McMILLAN SAND FILTRATION SITE COMMUNITY CENTER & PARK DESIGN UPDATES

COMMISSION OF FINE ARTS SUBMISSION

4 MAY 2023

McMILLAN COMMUNITY CENTER LANDSCAPE DESIGN UPDATE

Figure 18: Updated site plan enlargement showing exercise areas

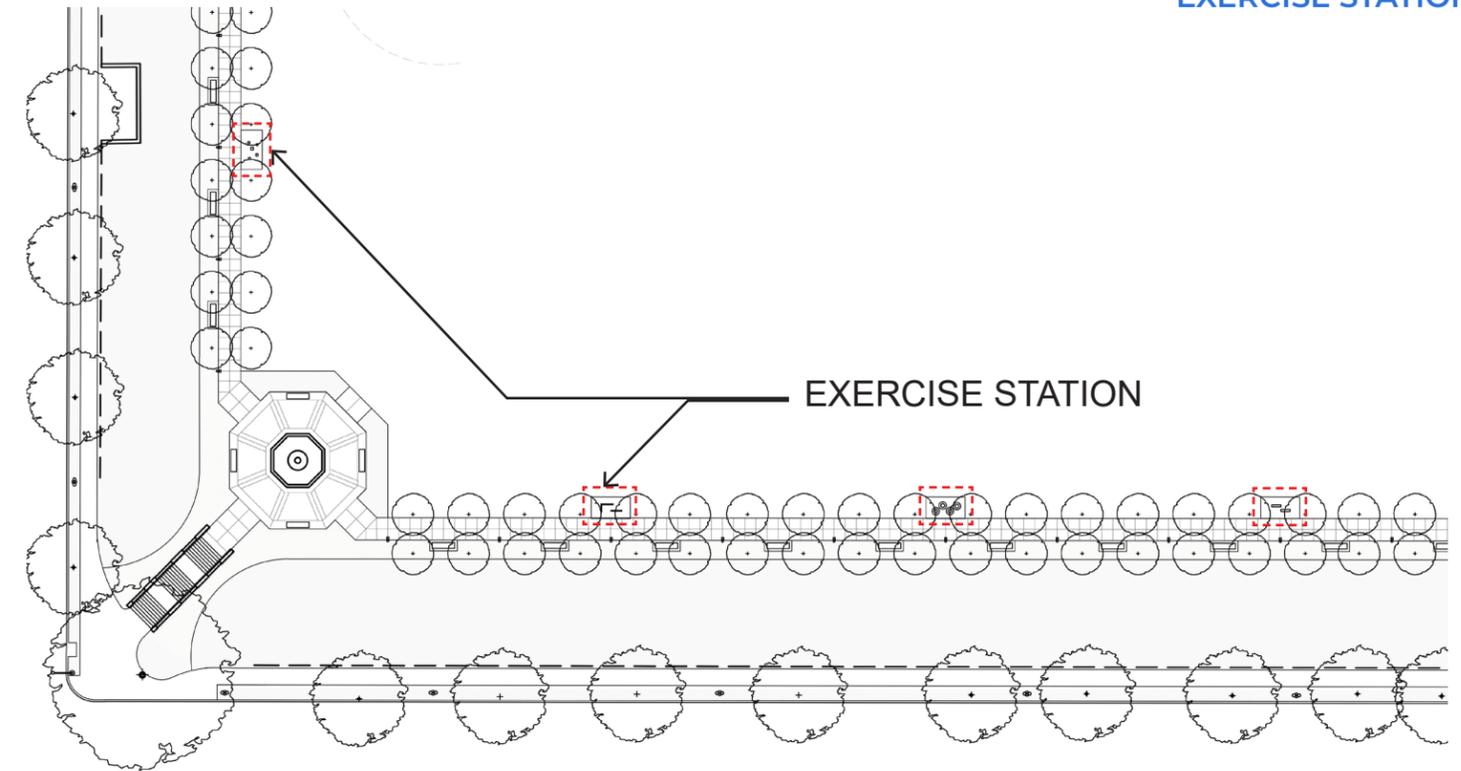
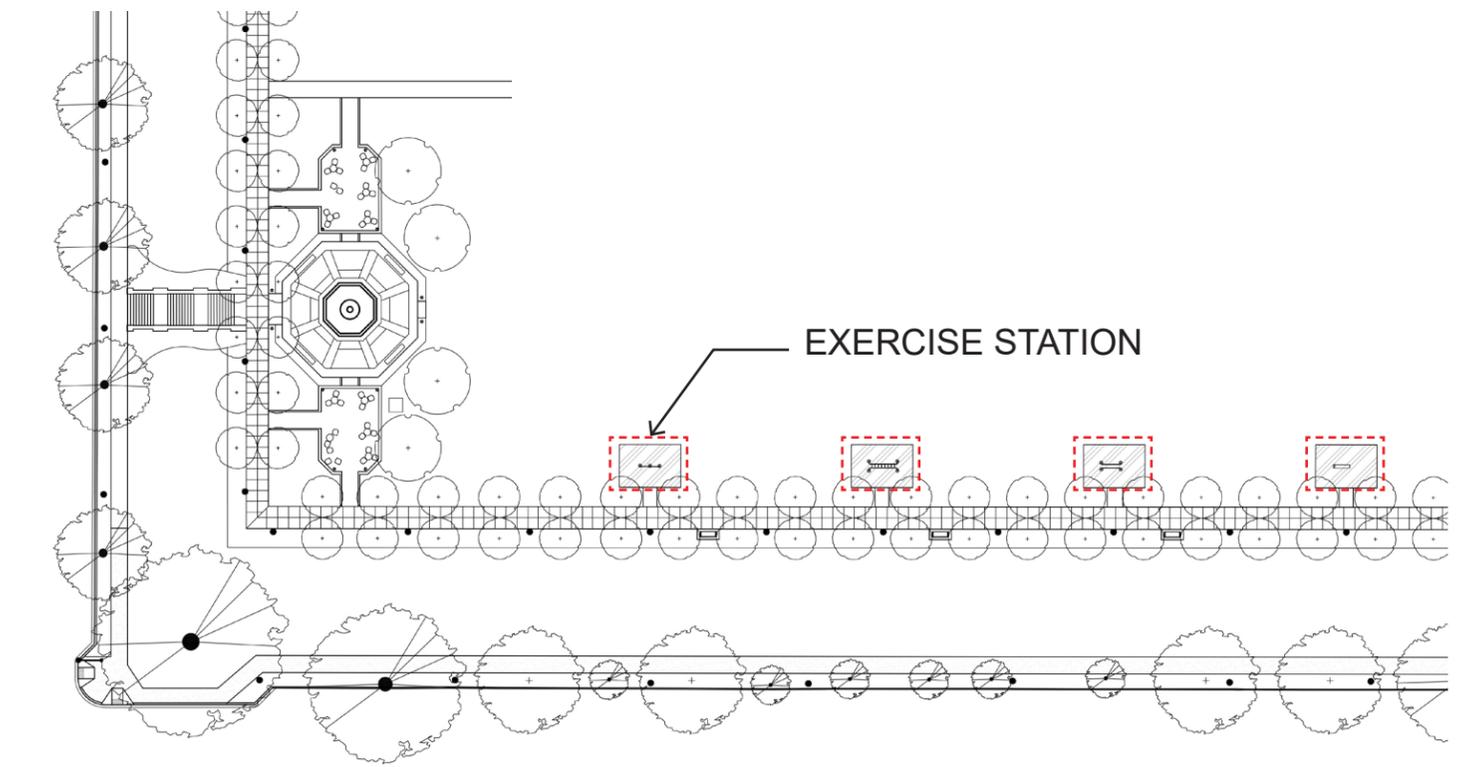
In June 2020, the Commission members recommended further study of the placement of exercise stations along the Olmsted Walk, commenting that using them may prove challenging due to their close proximity to the narrow walk. Exact sizing and layout of the fitness stations was unresolved pending coordination with DPR and the fitness equipment manufacturer.

The fitness stations have been consolidated along the southern stretch of the Olmsted Walk, and short paths lead to them from the path (see Figure 18). Olmsted Walk trees and fitness area layouts have been adjusted to provide adequate space for safe use of equipment and greater separation between uses of these areas and of the Olmsted Walk.

Tree spacing on the east-west leg of the Olmsted Walk is 21 feet on-center; the spacing on the north-south legs remains 20 feet on-center. The surfaces depicted are sized as required for safe use of the fitness equipment following the guidelines from the manufacturer.

Figure 20: Updated site plan showing North Capitol Street public space.

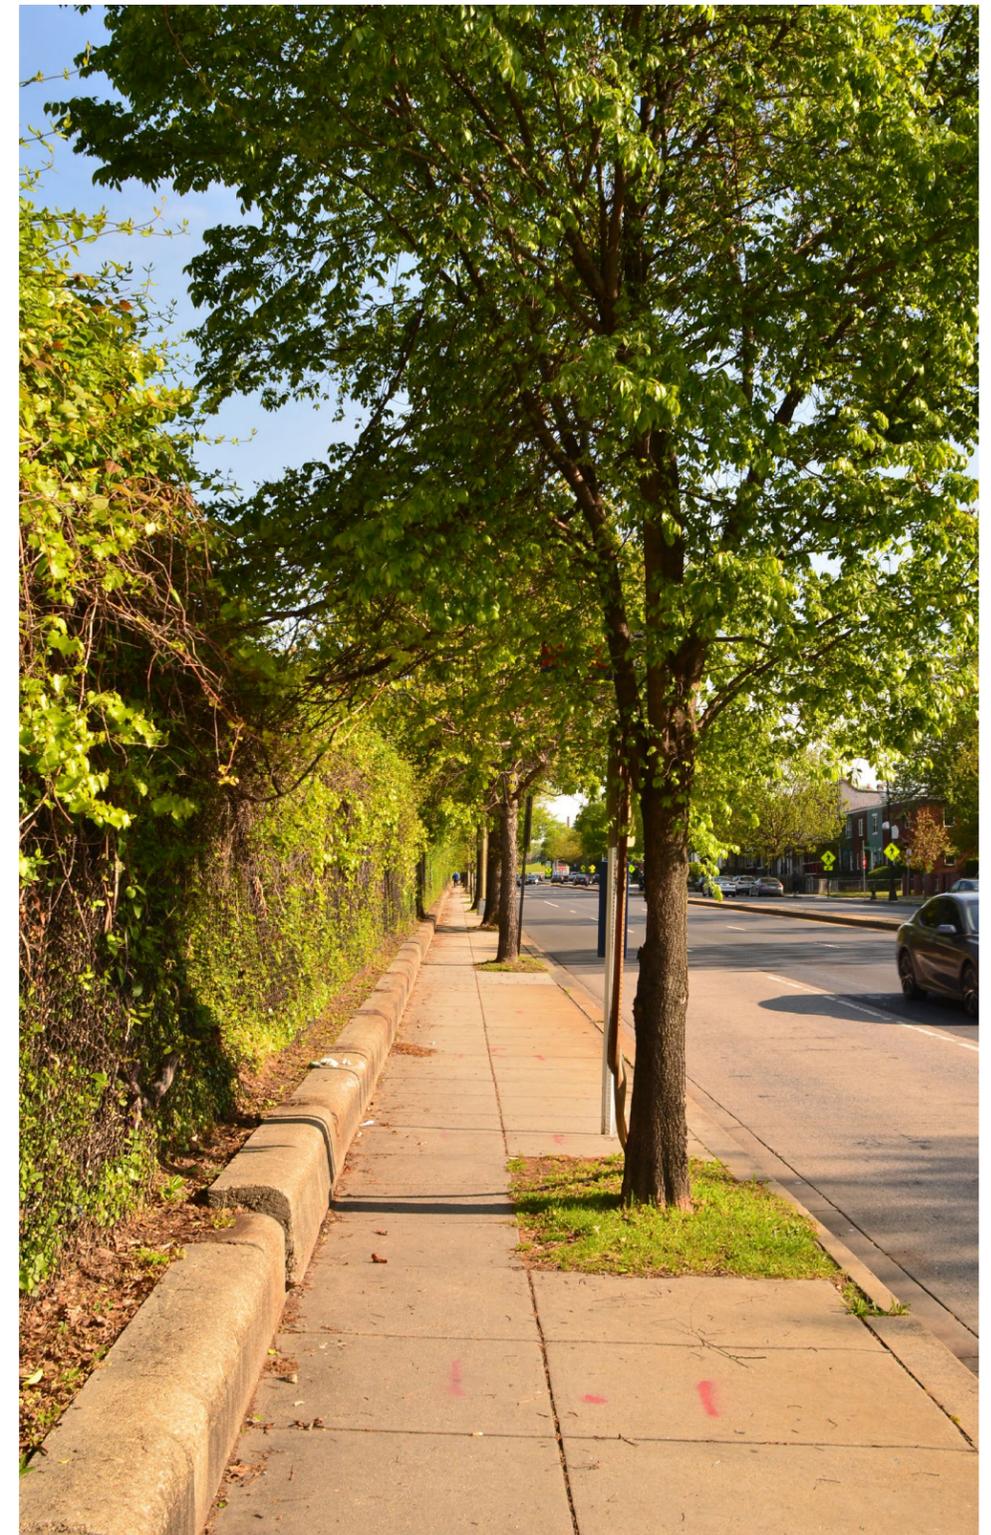
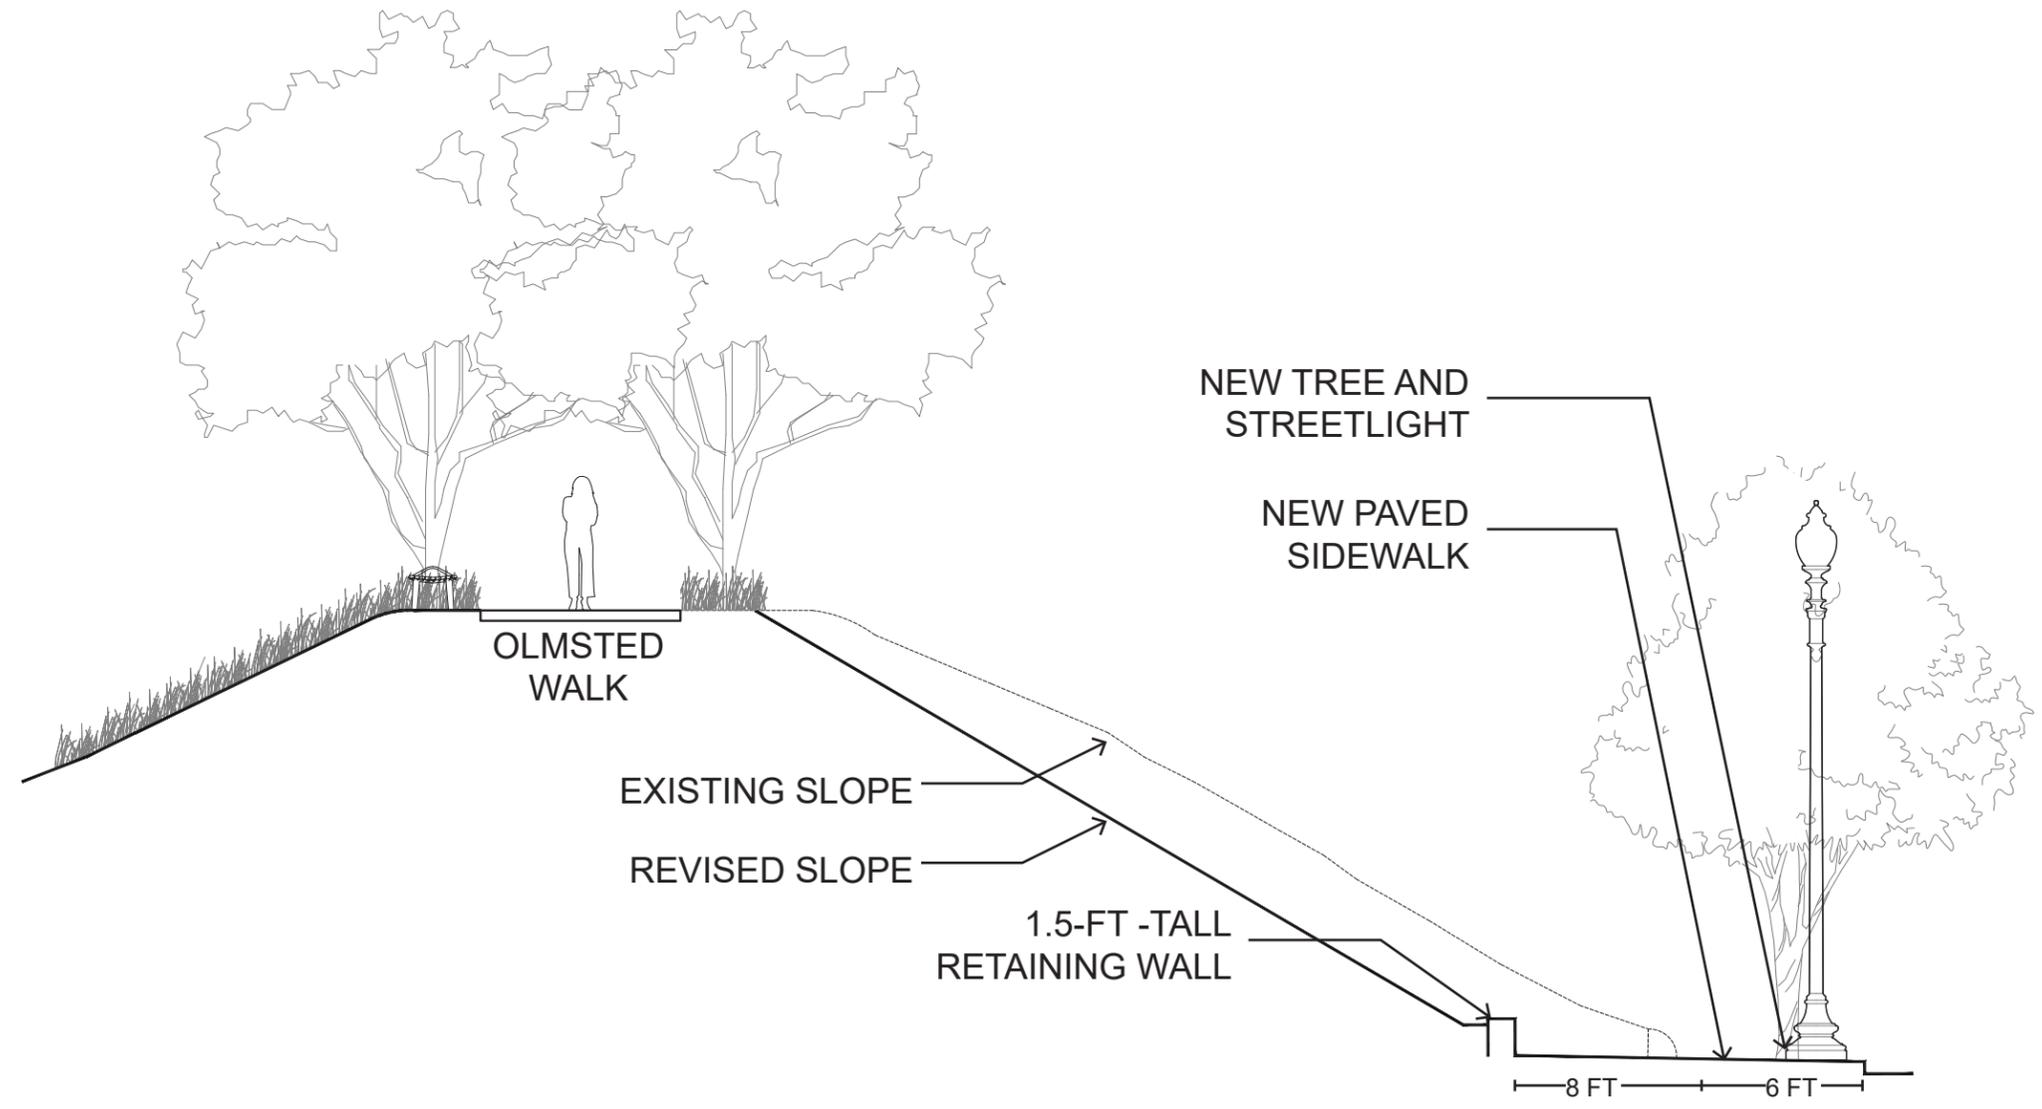
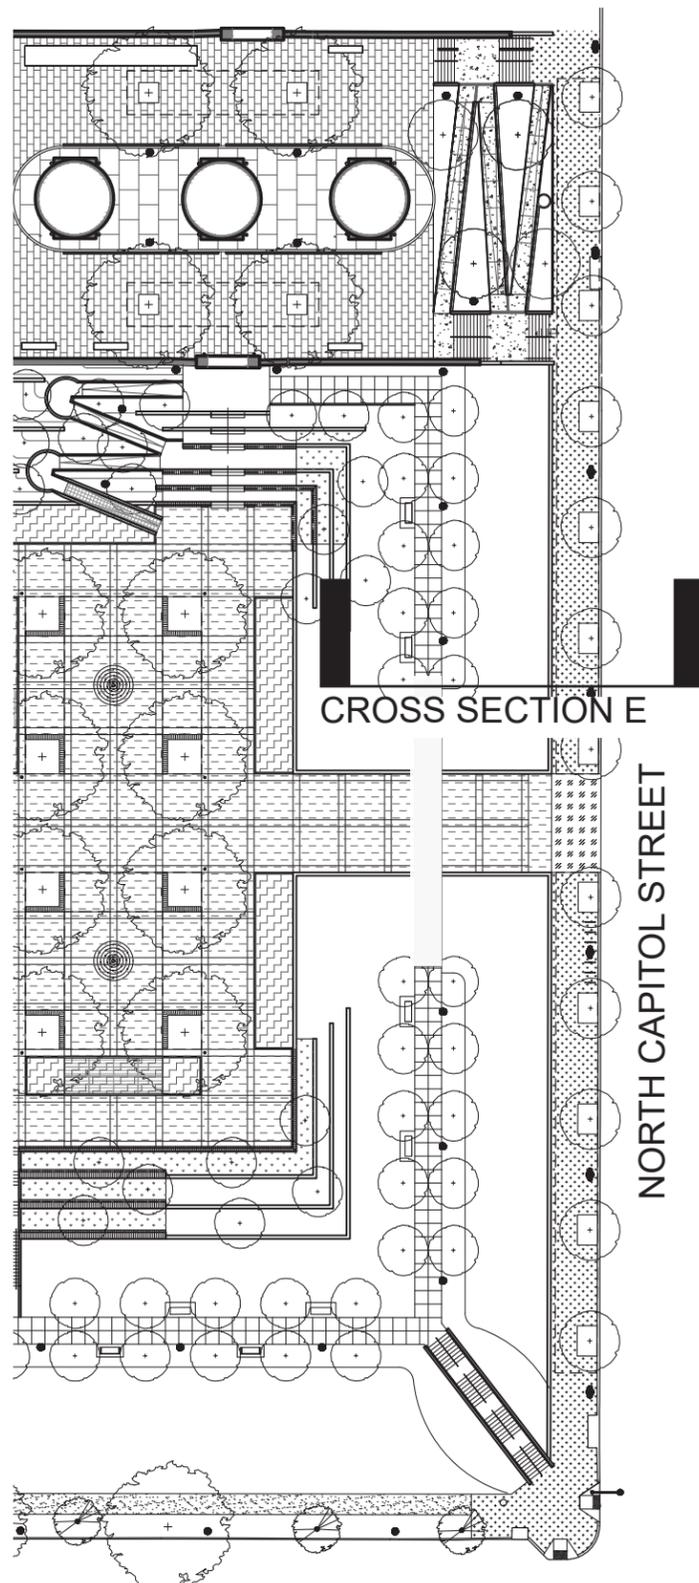
When presented to the Commission of Fine Arts in June 2020, the design did not include revisions to the existing sidewalk and trees along the west side of North Capitol Street. After the CFA submission, the design team was made aware of design guidelines for the North Capitol Street public space prepared by the DC Office of Planning and Department of Transportation. These guidelines stipulate that the sidewalk along North Capitol Street should be 14 feet wide, with a 4-6-foot-wide furnishing zone and an 8-10-foot-wide sidewalk zone.

The design has been updated to provide the required 14-foot-wide sidewalk, as shown in Figure 20. Associated with this change, twelve new trees will be planted and DDOT-required soil volumes will be met. Because of the wider sidewalk, the existing berm facing North Capitol Street must be modified to push the toe westward. A new retaining wall will be constructed and reinforced geotextile stabilization will be added to prevent sloughing of the revised slope.
